BOARD/COMMISSION: Nickel Plate Review Committee Meeting

4. Cafe Patachou

Case: NPR-23-3

Nickel Plate Review Committee Staff Report

EXTERIOR
ELEVATIONS

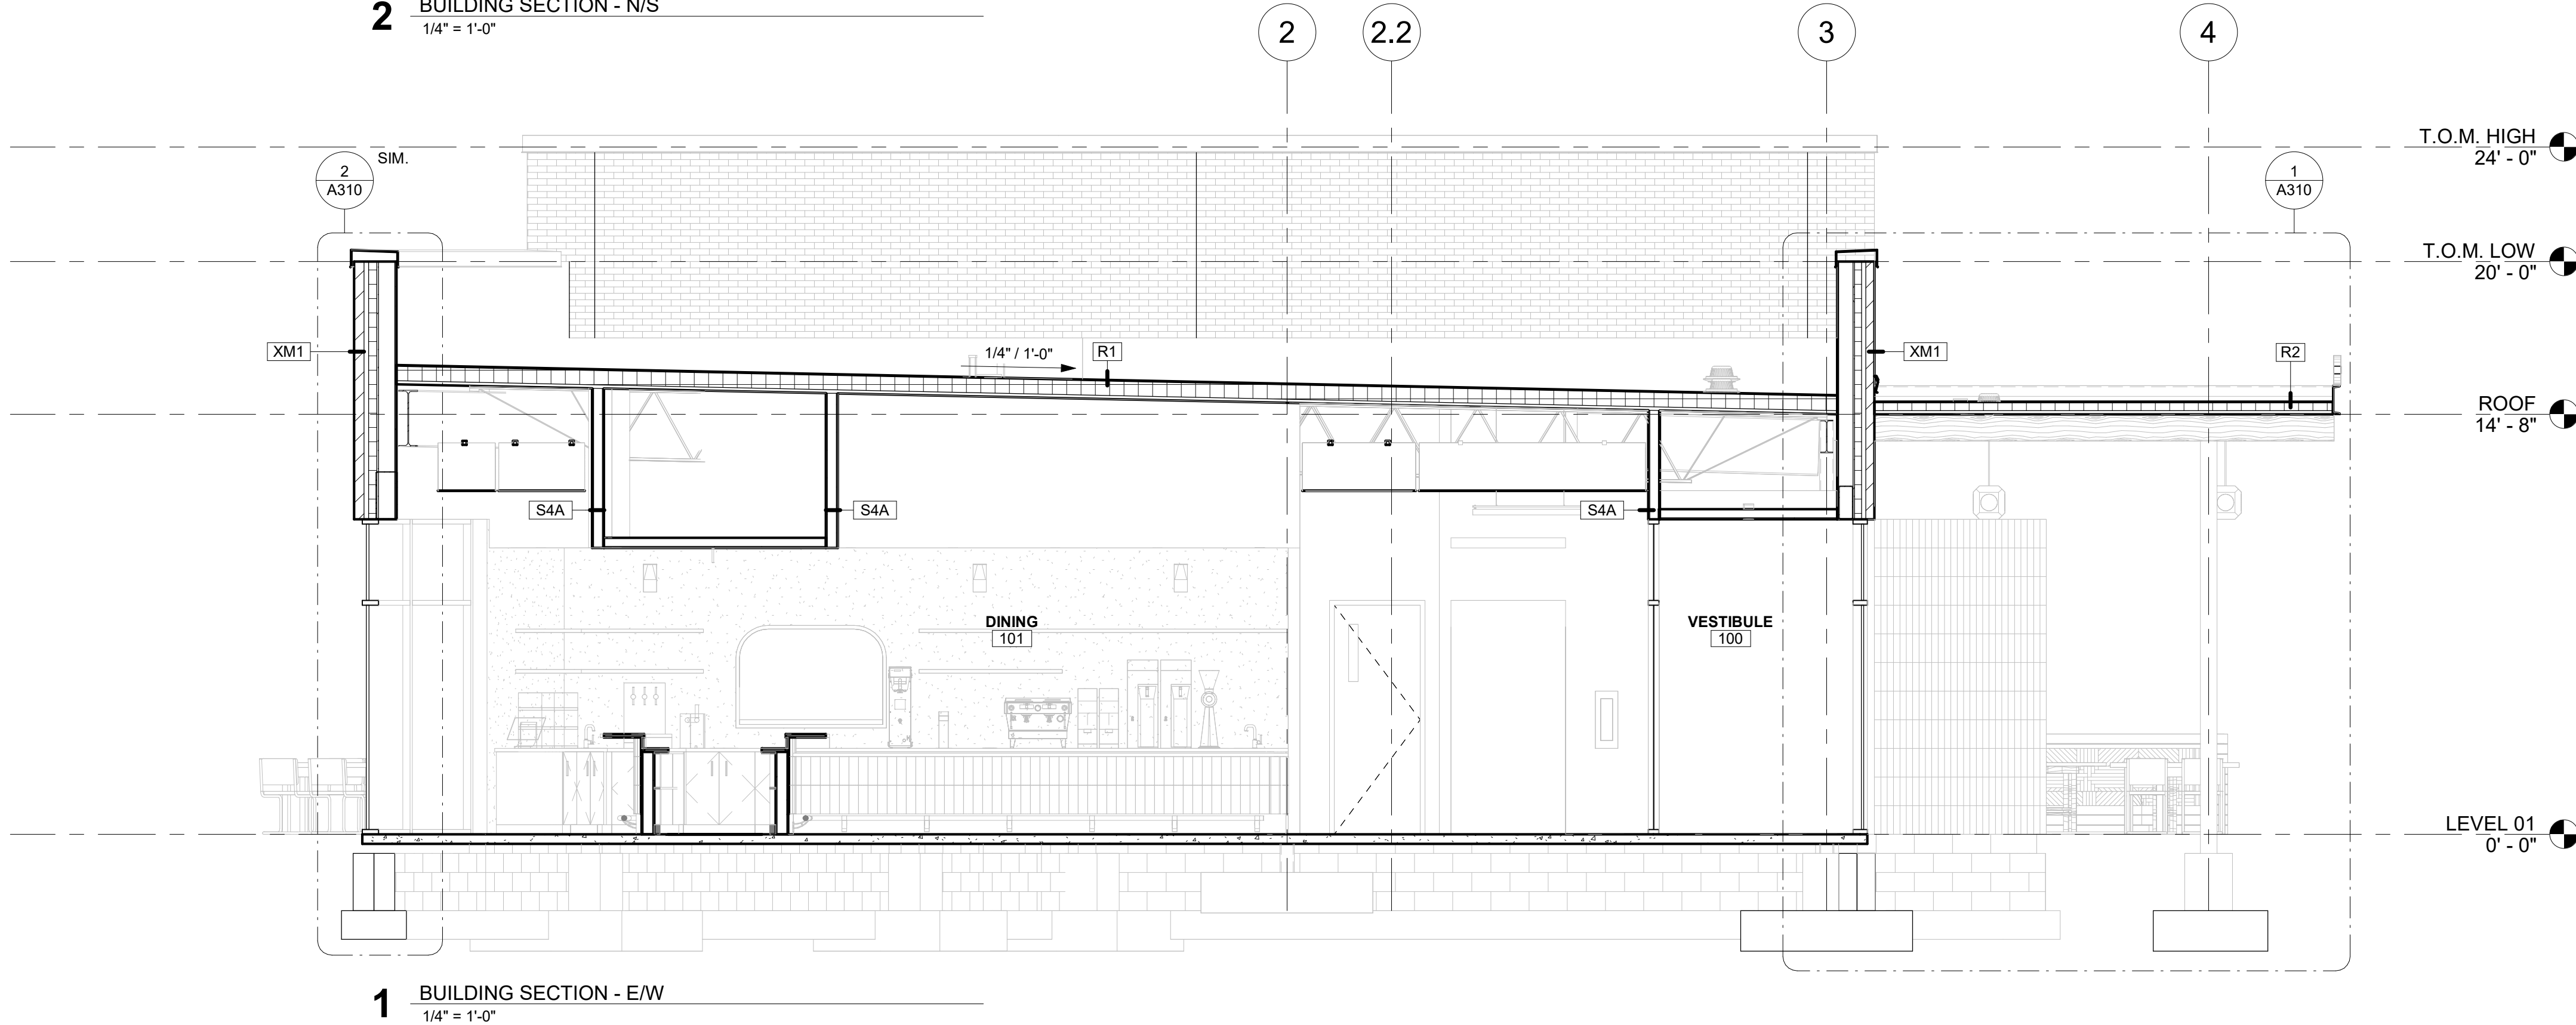
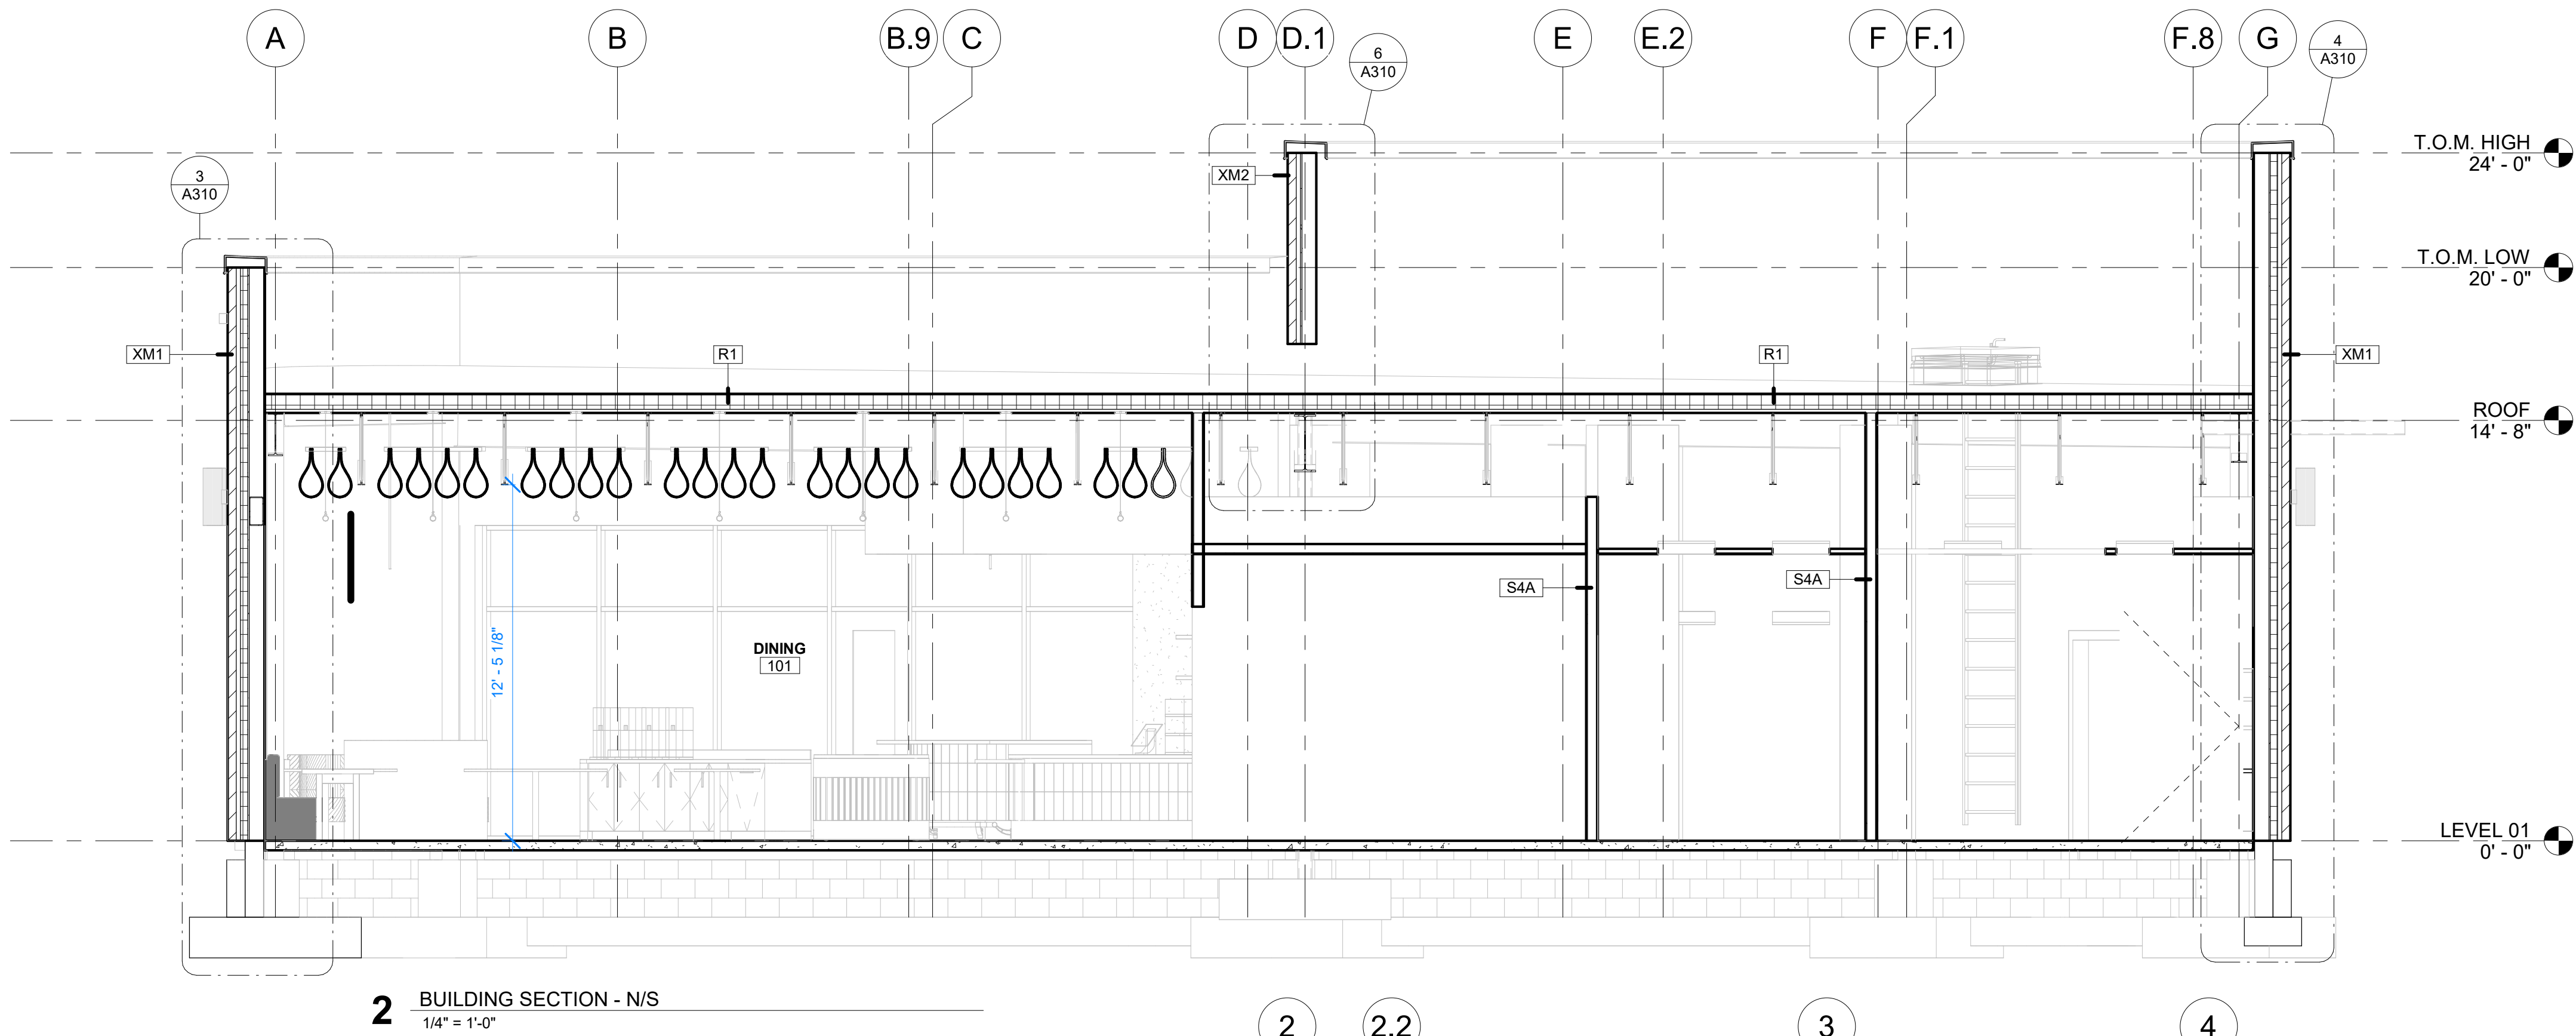
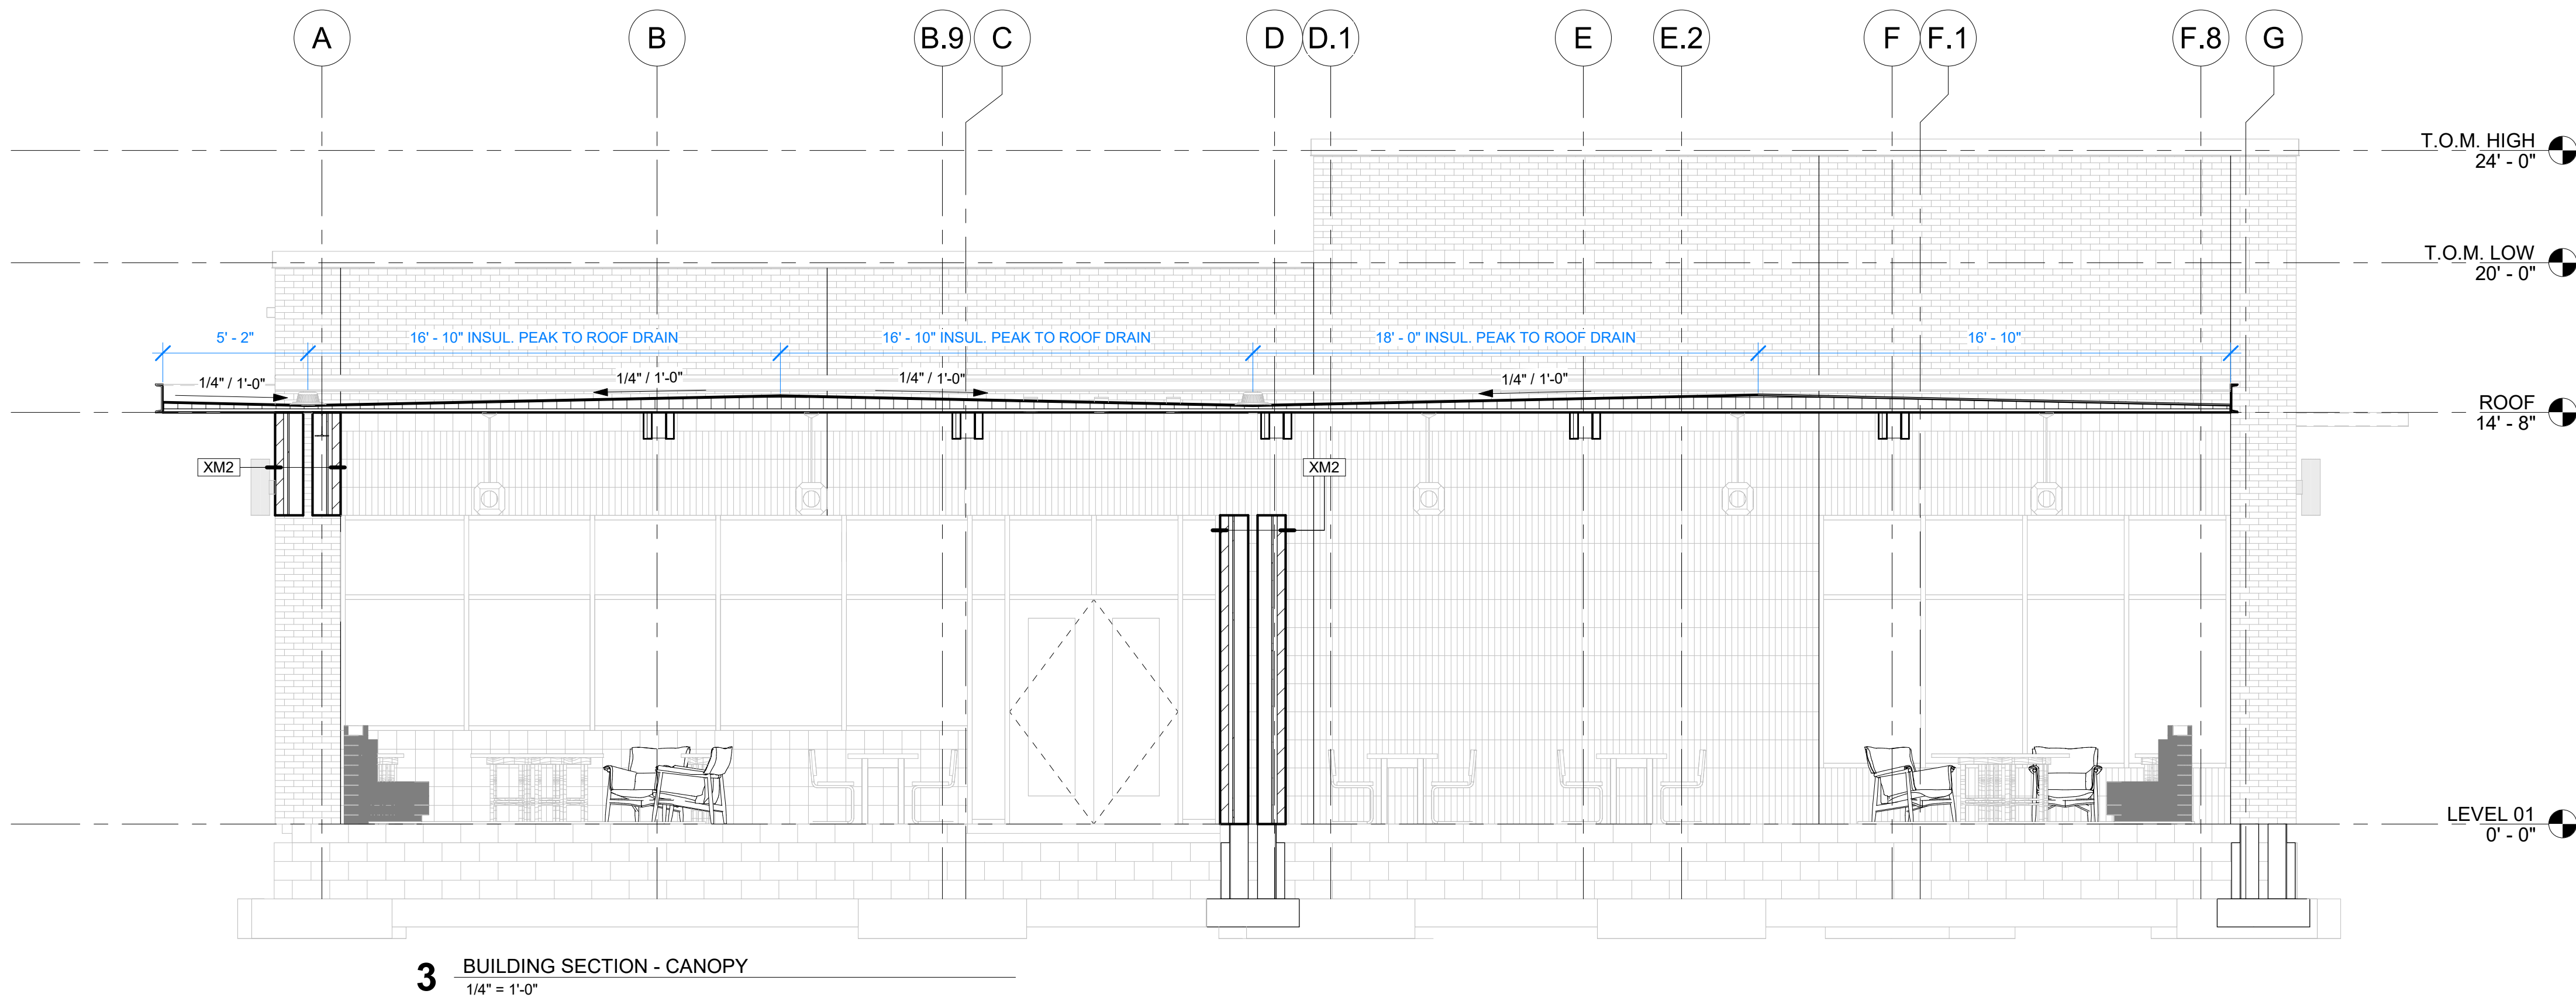
✓ Façade Articulation: Façade articulation and multiple material are provided along the south, east, north side of the building with multiple material changes on the west side.

✓ Four-sided architecture: four-sided architecture is provided with two plus building material, a mixture of masonry, and glass.

✓ Exterior Materials: Two Brick Veneer materials are proposed, one dark and one light per the color elevation.

✓ Color: brick veneer a combination of Dark Ironspot (artisan), Medium Ironspot (smooth), Grey Blend (smooth) and Manganese Brown (smooth) are all muted colors.

1. Primary Minimum Height – The Nickel Plate Code Requires a minimum height of 3 stories / 36 feet; Petitioner is requesting a 1 story / 24 feet structure.

Staff is supportive of the primary minimum height waiver. With the context of the existing legacy buildings being two stories and pedestrian scale of this area adjacent to the plaza and Nickel Plate Trail, the building will provide multiple planes including a roof at nearly 14' 8" near the entrance,

and two additional roof planes at 20' and 24'.

1. A Nickel Plate District corner stone is added to the façade adjacent to the right-of-way.

Café Patachou Rendering

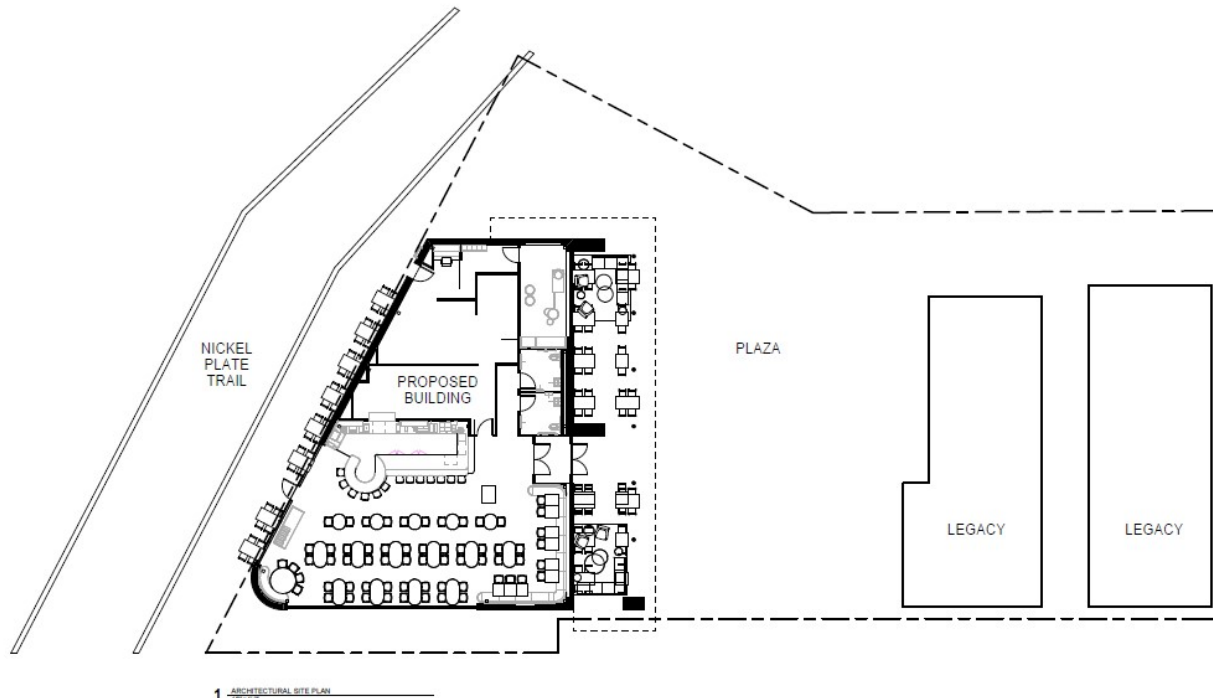
✓ Mechanical & Utility Equipment Screening: HVAC will likely be located behind a roof parapet wall, currently proposed at 10 feet. Staff will review during the TAC process if this parapet wall needs to be extended.

✓ Defined Entrance: Building has a defined entrance along the east façade, adjacent to the Legacy Plaza

✓ The building includes a defined base, middle, and top: building has a defined base with a change of material and defined entry awning and windows. The cantilevered roof provided a
